**MELBOURNE METRO RAIL PROJECT ENVIRONMENT EFFECTS STATEMENT INQUIRY
AND ADVISORY COMMITTEE**

MMRA TECHNICAL NOTE

TECHNICAL NOTE NUMBER: 027

SUBJECT: Transport

Updated Figure 8-20 Domain station precinct travel times - 2021 Construction Case - One-lane - AM Peak

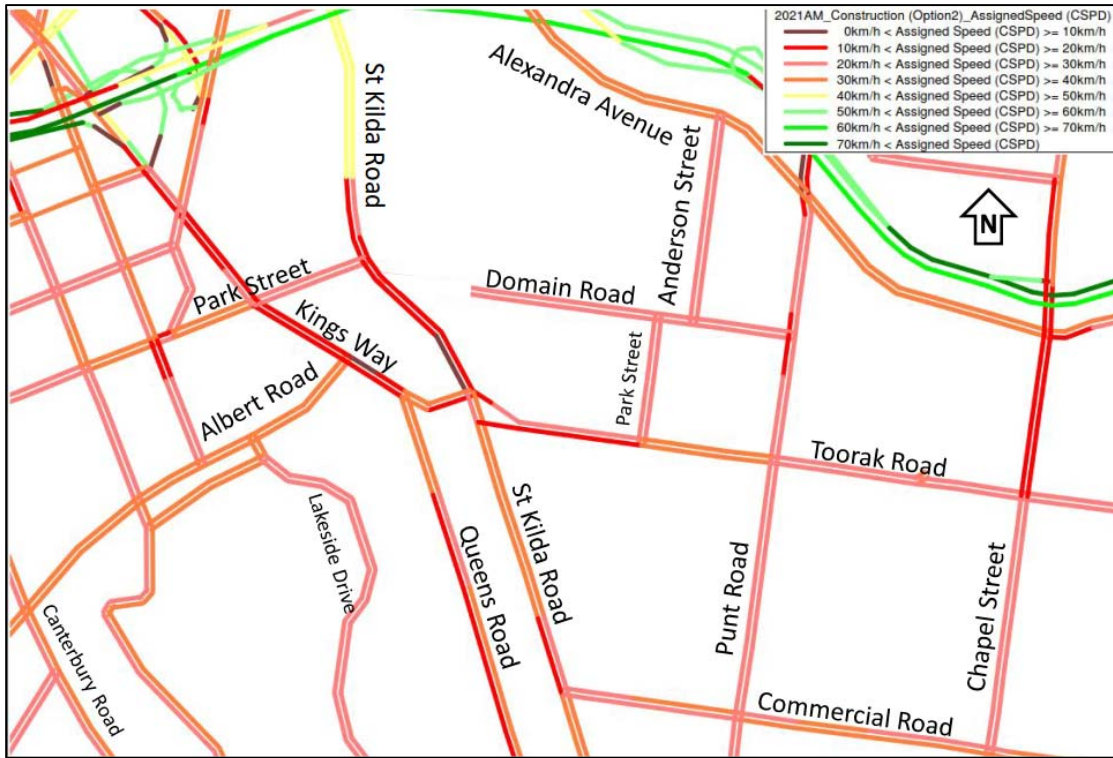
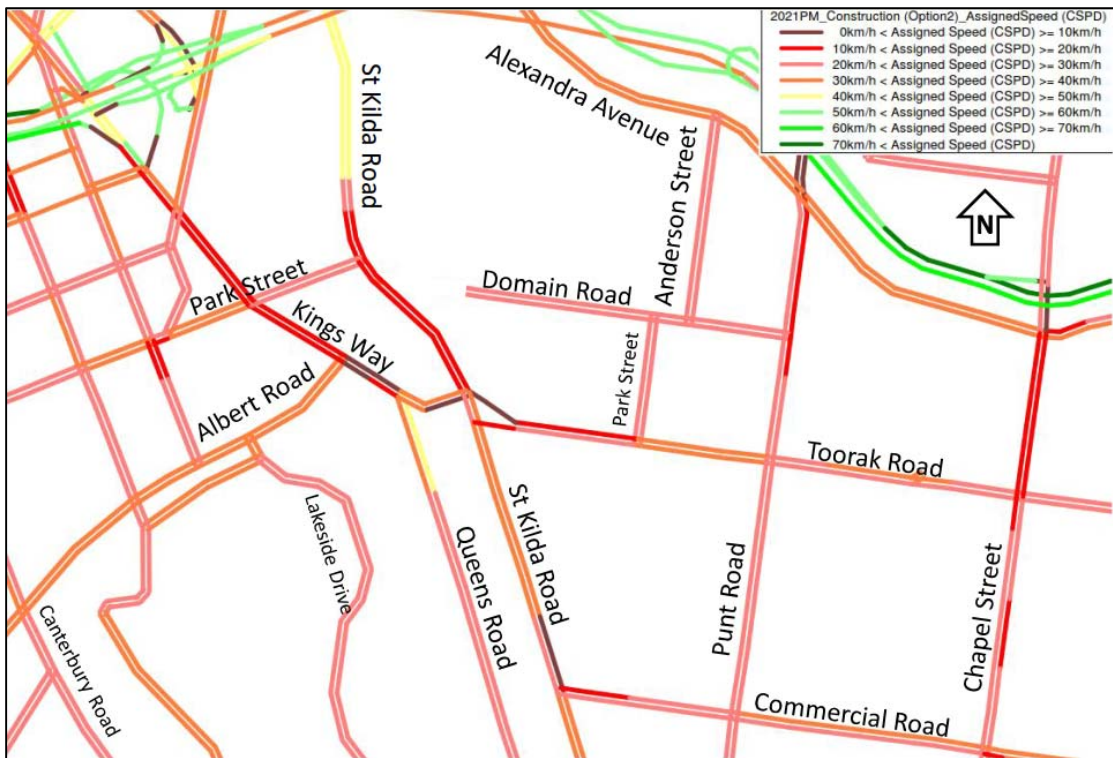
The TIA at p139-140 - Figures 8-20 and 8-21 Domain station precinct travel times – 2021 construction case do not indicate the closure of Domain Road.

- 3. *confirmation that the outputs reflect conditions with the closure of Domain Road to general traffic.*

- 12. It is confirmed that the models include the closure of Domain Road. In this case, the closure has been implemented in the model by banning turns, having the effect that traffic does not travel along Domain Road during the closure period. The video animations for the Domain Station – Domain tram interchange provided in response to Request 2 above show the closure.
- 13. Revised versions of Figure 8-20 and Figure 8-21 showing the closure of Domain Road are presented below:

Updated Figure 8-21 Domain station precinct travel times - 2021 Construction Case - One-lane - PM Peak

Figure 1: Daily traffic profile on Domain Road approaches to Birdwood Avenue (Source: SCATS 28 July 2016)

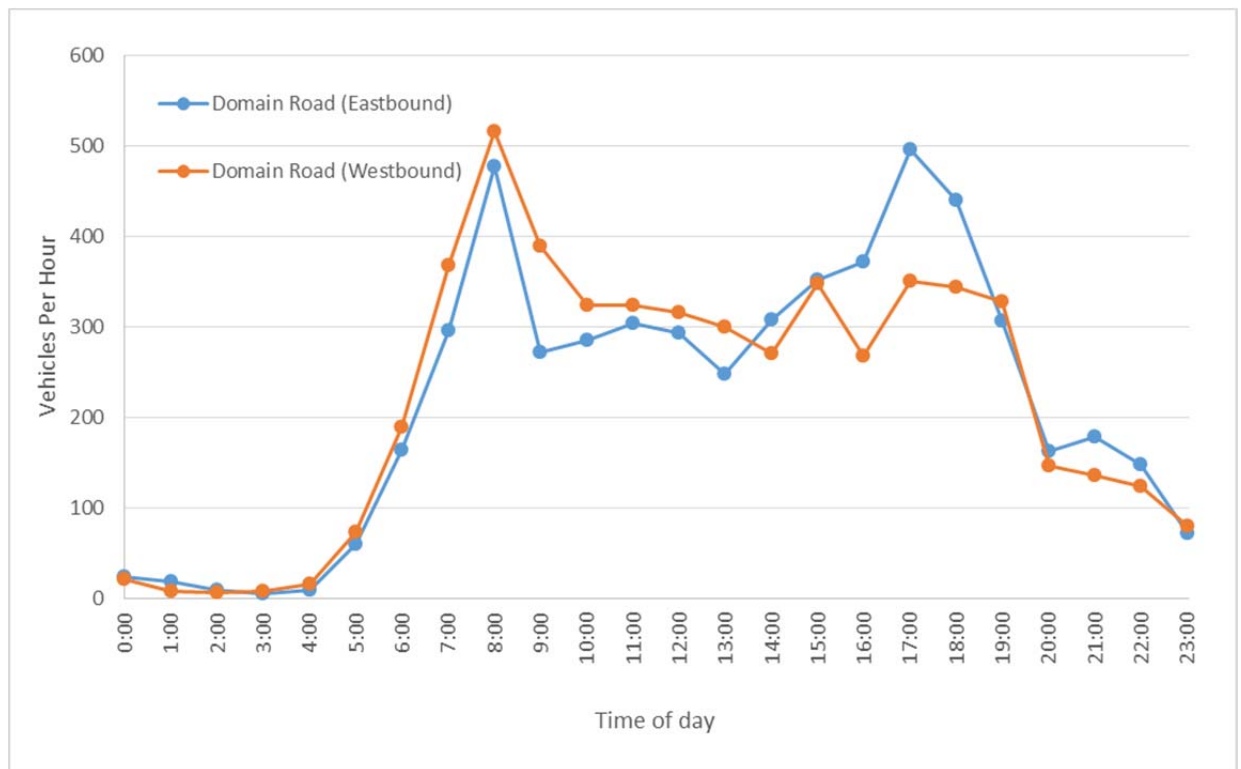
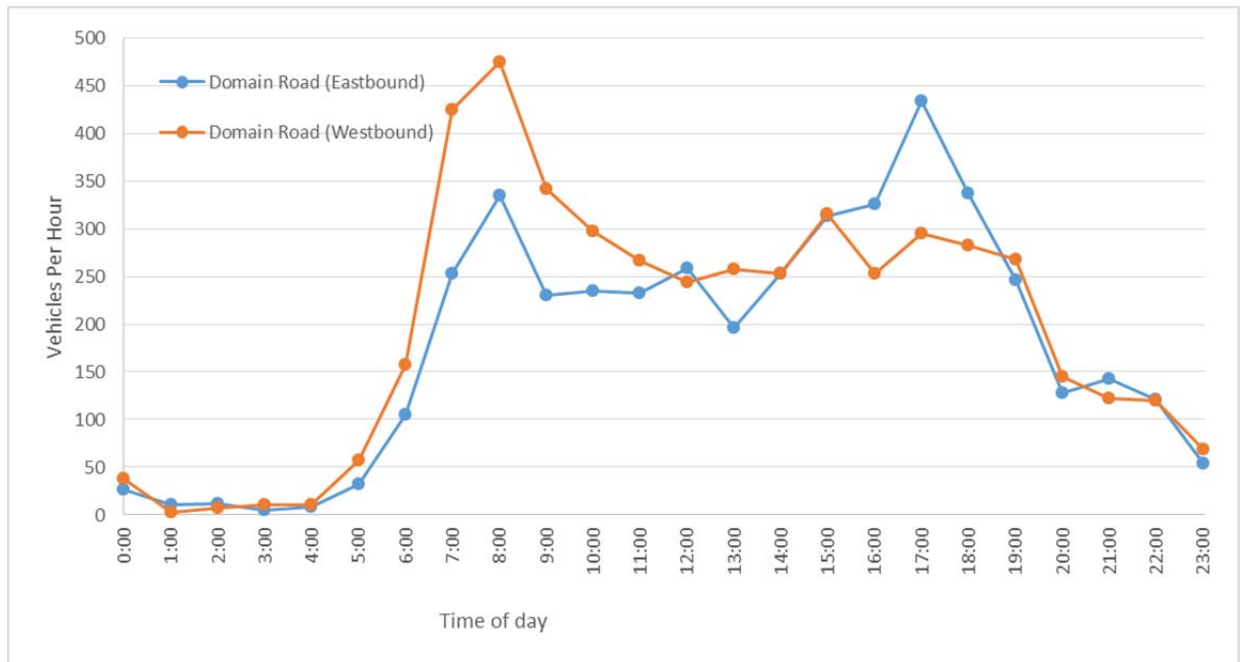
Appendix B – Existing Transport Conditions at p88-89, Figure 7-3 and Table 7-5 headings indicate the inclusion of existing traffic volumes for Domain Road, but they are not shown.

- 4. the existing Domain Road traffic volumes.

14. Domain Road traffic volumes are shown in the graph below.

Figure 2: Daily traffic profile on Domain Road approaches to pedestrian crossing at Dallas Brooks Drive (Source: SCATS 28 July 2016)

Figure 3: Proposed site for replacement car parking at Western Portal during construction

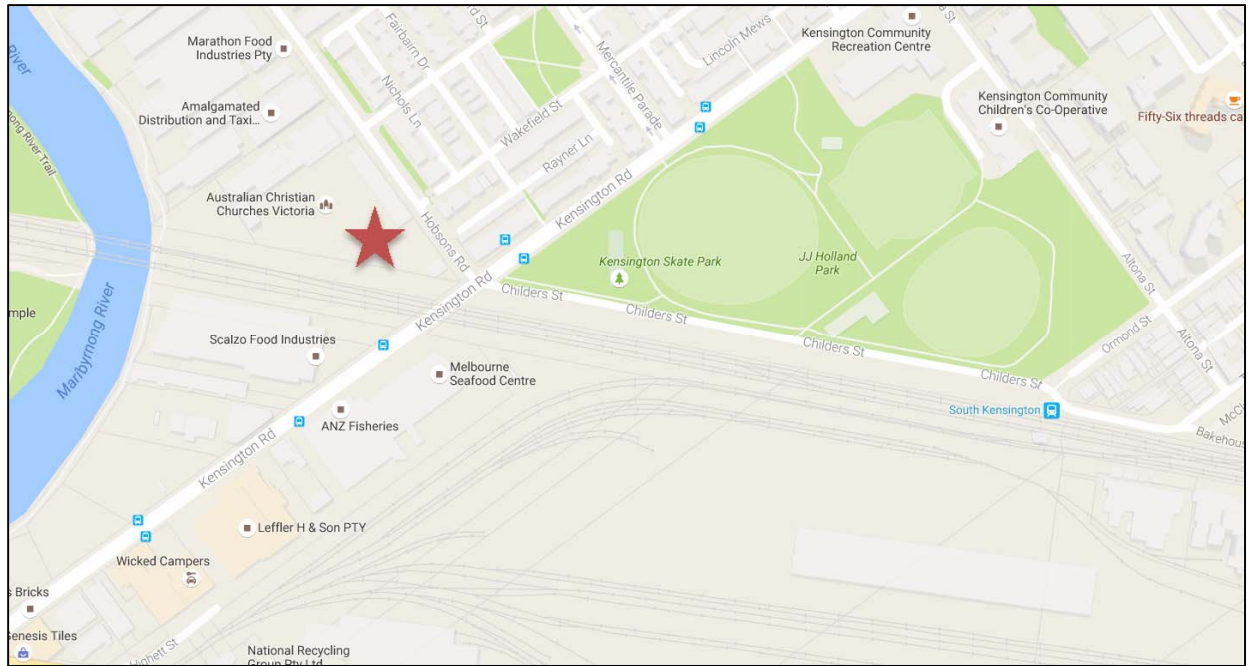
Options are being investigated to provide replacement parking in the vicinity of the station to minimise impacts on rail patrons driving to the station and users of JJ Holland Park, but details are not available at the time of writing ...

8. *an update on this investigation and the results of that investigation.*

22. An assessment determined that there is only one practical site for the replacement parking at the Western Portal for South Kensington station patrons.
23. The proposal is to construct car parking on the vacant site on Hobsons Street to the east of Kensington Road as shown below. The new car parking area will require passengers to cross Kensington Road and walk along the existing path along the northern side of Childers Street through the JJ Holland Park to access the station entrance near Ormond Street. No other options have been identified that provide a more practical solution to the loss of car parking.
